SWIM PROJECT PROFILE		Pilo No. : 166
Regist. No. : Agency No. : BSWM-80	Name: CAMBURAY SWIP	
Region: 4	Province: OCCIDENTAL MINDORO	Municipality: SAN JOSE
Present Status: 1. Pro-F/S() ② F/S(1985) ③ D/D(1985)		
Purpose: Major : Irrigation Incidental : IF, FC, WM		
Project Feature:

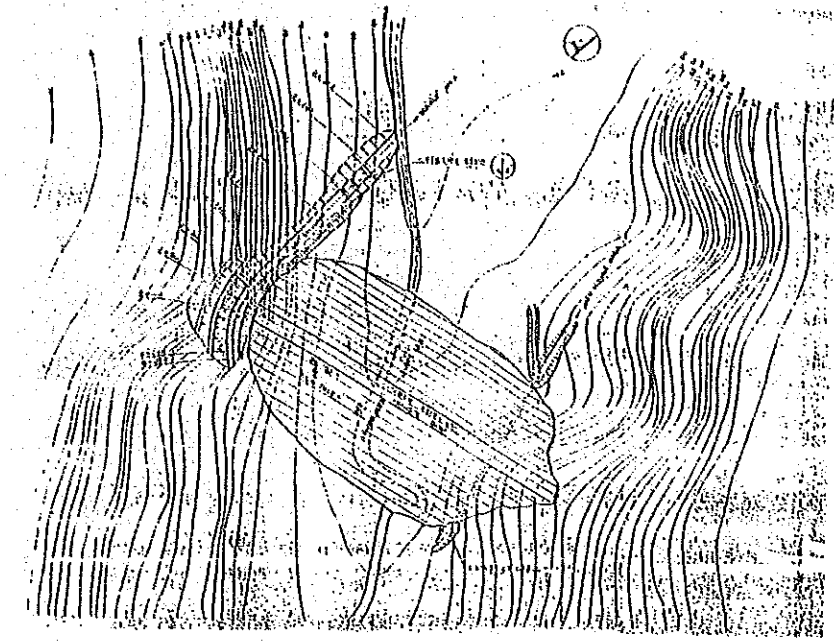
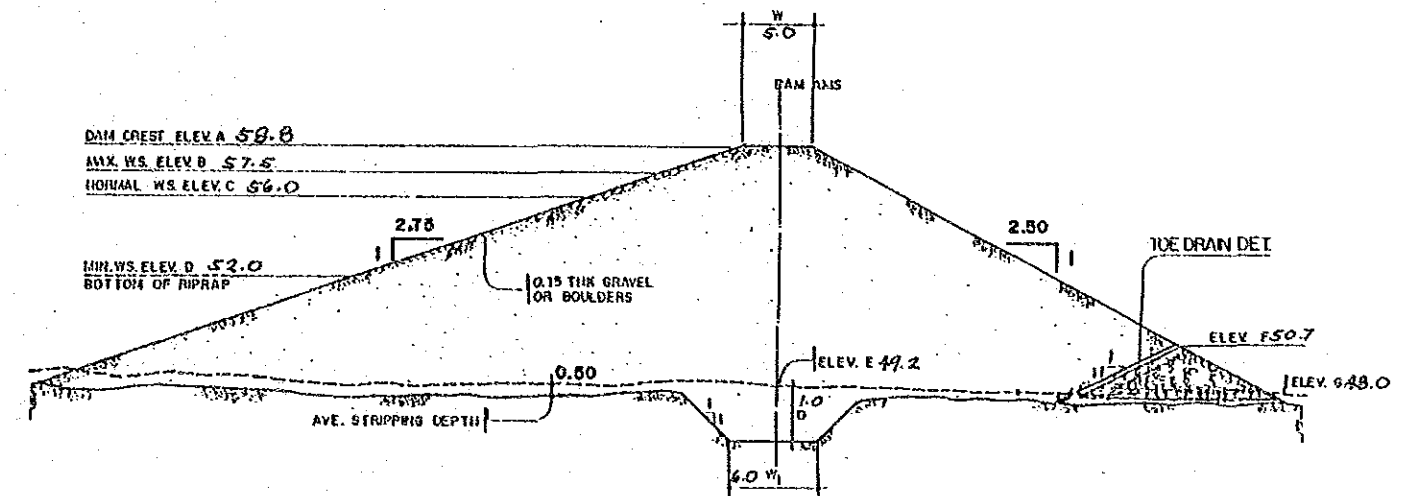
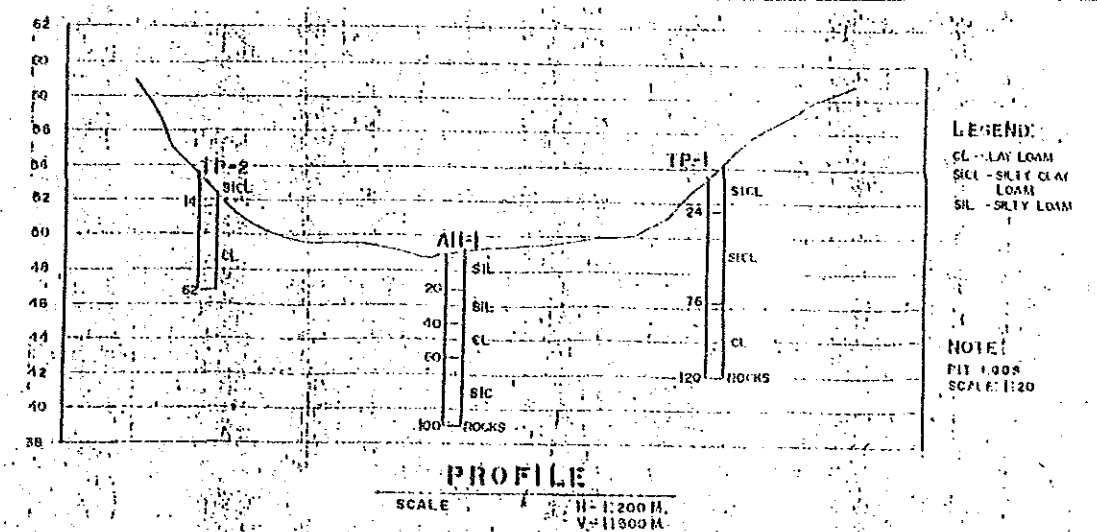
2. Planning Environmental conservation plan is not formulated. Project planning shall be re-formulated.		
3. Design Depth of core trench shall be modified during construction. Stability of upstream slope of the dam shall be checked. Centerline of the spillway shall be shifted to left side. Weir shall be provided in the spillway.

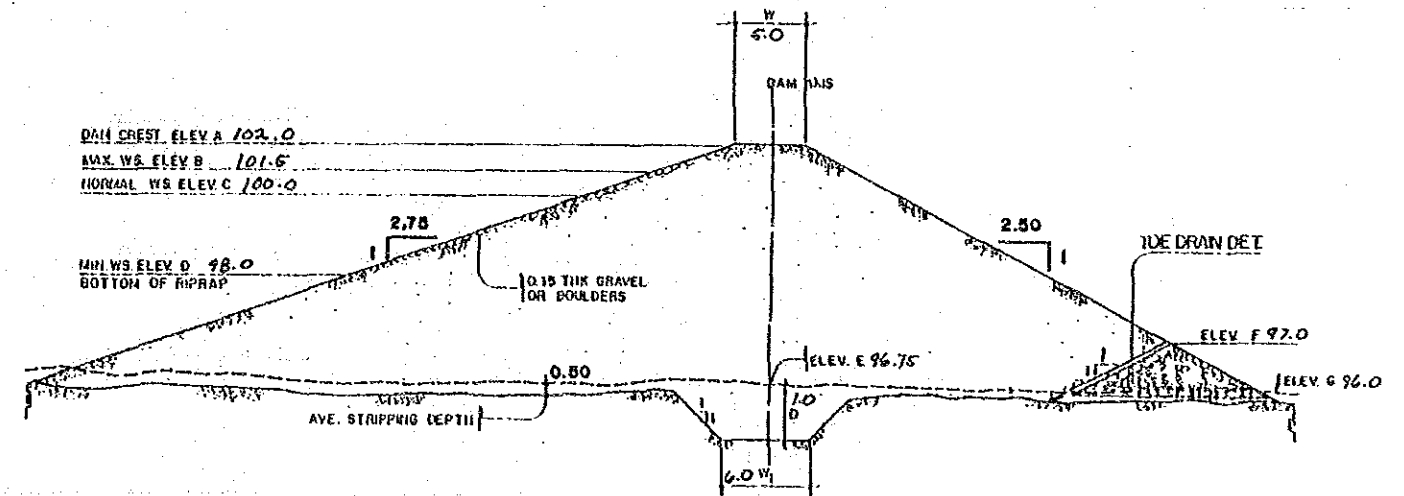
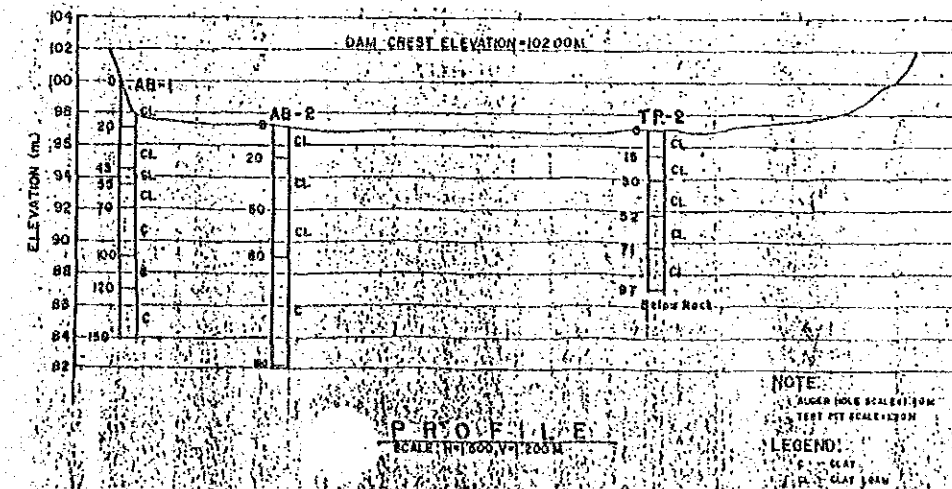
2. Planning Environmental conservation plan is not formulated.		
3. Design Depth of core trench shall be modified during construction. Stability of upstream slope of the dam shall be checked. Centerline of the spillway shall be shifted to right side. Weir shall be provided in the spillway.

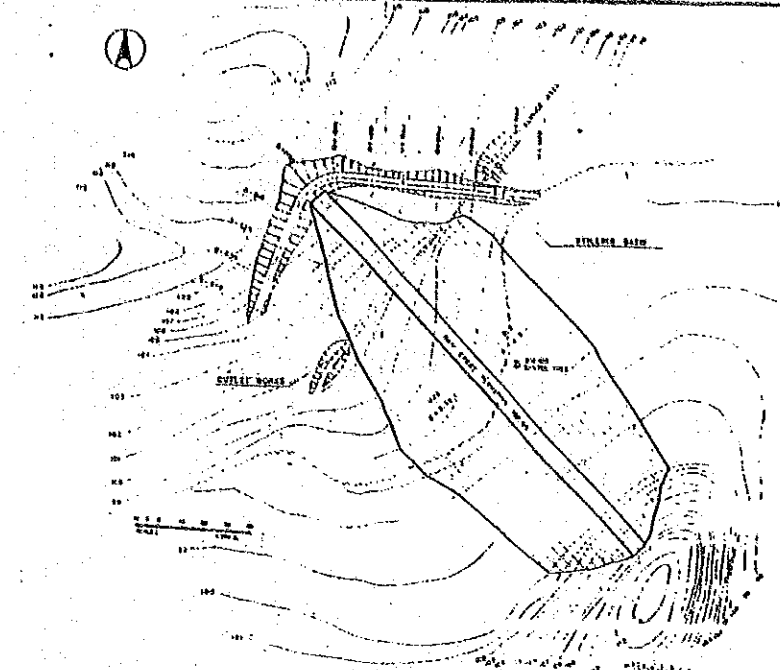
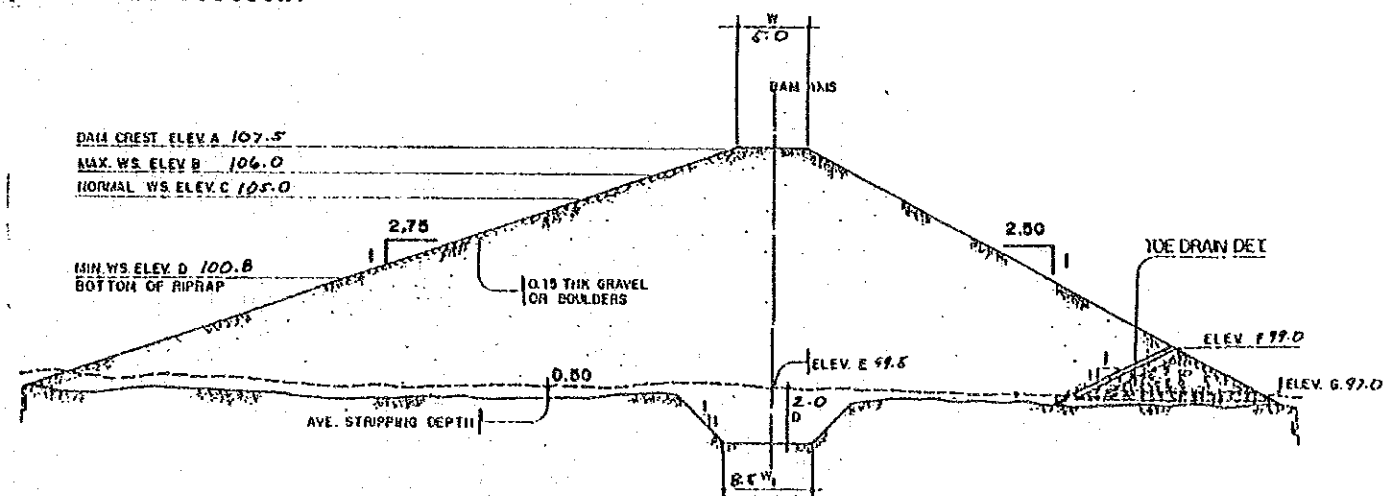
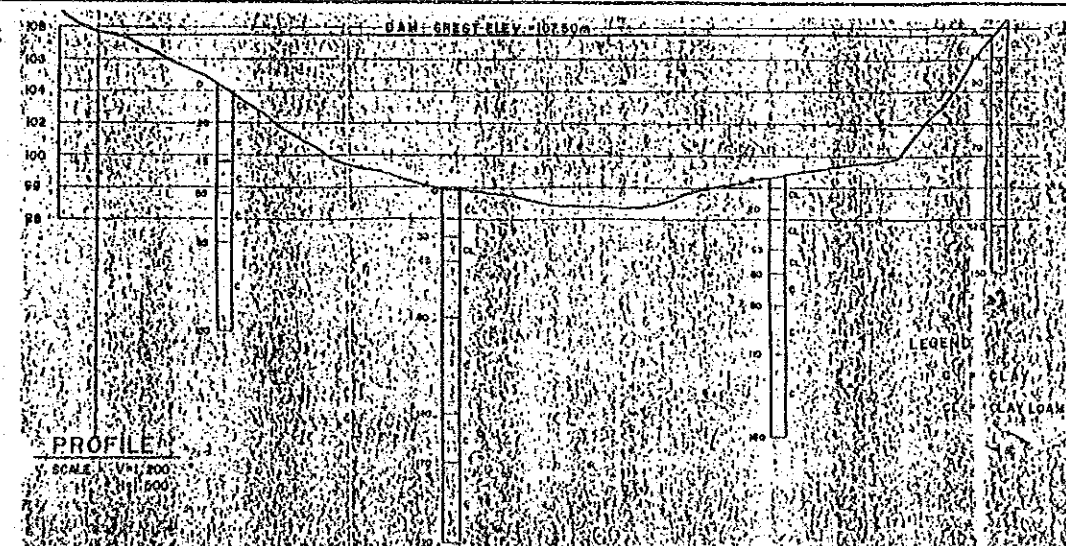
2. Planning Environmental conservation plan is not formulated.		
3. Design Depth of core trench shall be modified during construction. Stability of upstream slope of the dam shall be checked. Centerline of the spillway shall be shifted to left side. Weir shall be provided in the spillway.

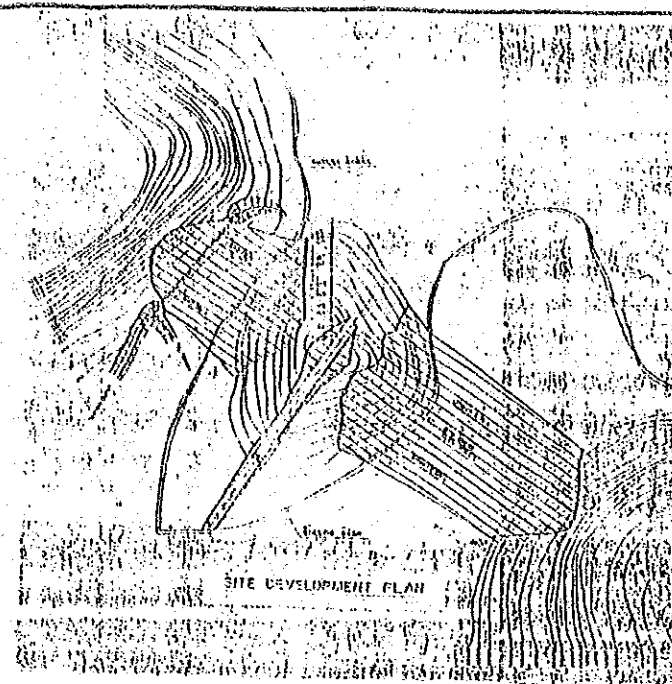
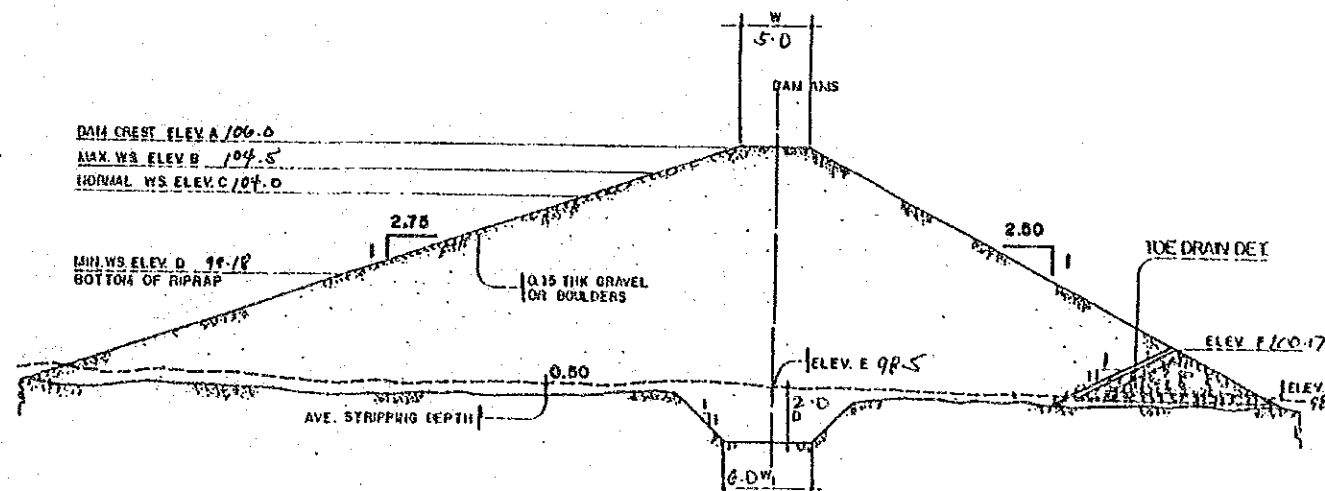
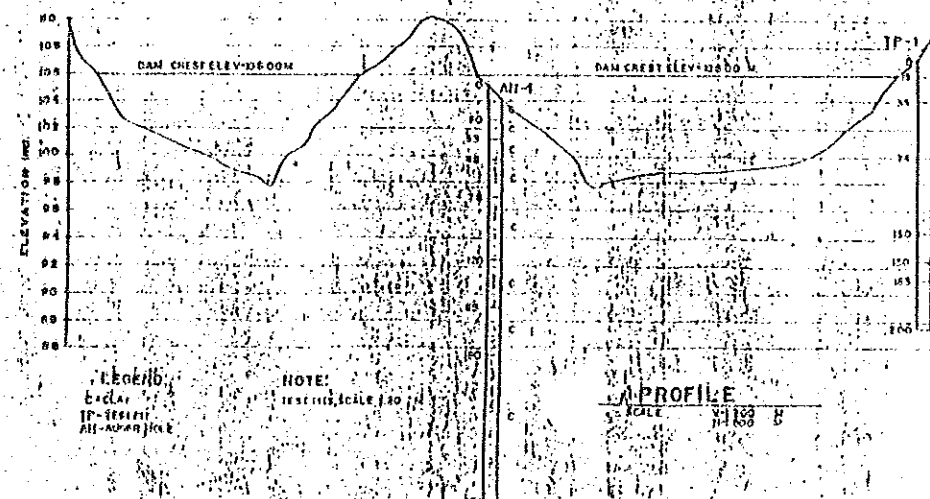
2. Planning Environmental conservation plan is not formulated.		
3. Design Depth of core trench shall be modified during construction. Stability of upstream slope of the dam shall be checked. Freeboard is not enough. Weir shall be provided in the spillway.

Note: Clay with more than 3.0 m depth is piled up on the sand stone and shale. Additional 0.5 m freeboard is necessary.
